## 2 Type of change

All product types listed in section 1 receive a new label layout.

Product Change Notification					Global Labeling Ph. 3 Voltage Selector		
owner	creation date	release date	released by	change order no	rev	page	D10-056-053
vetersa	12.03.2021	15.03.2021	haeckima	2021676	A	1 of 2

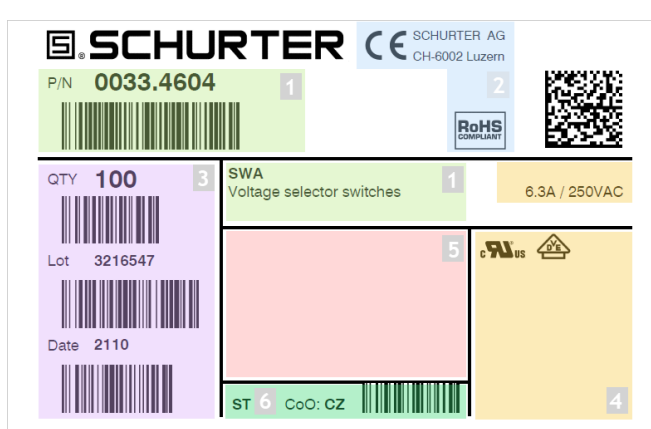
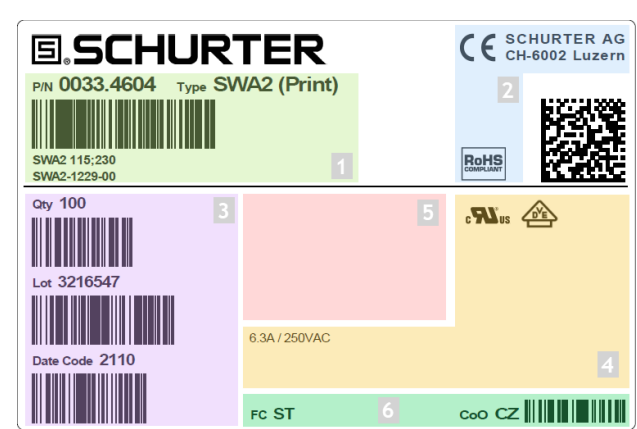
To better visualize the changes, we have used colors and numbers to cluster information into the following sections (The colors and white numbers are not part of the new label layout):

<b>Product identification section:</b> To improve readability, we clustered all the information concerning product identification in this group. To increase clarity, we introduce our product configuration code into this area.	1
<b>Product conformity section:</b> Identical information was slightly rearranged.	2
<b>Product logistics section:</b> Label names changed. Information was slightly rearranged.	3
<b>Product approval section:</b> Identical information was slightly rearranged.	4
<b>Interruption ratings section:</b> Identical information was slightly rearranged.	5
<b>Origin information section:</b> Label for Factory Code was added. Information was slightly rearranged.	6
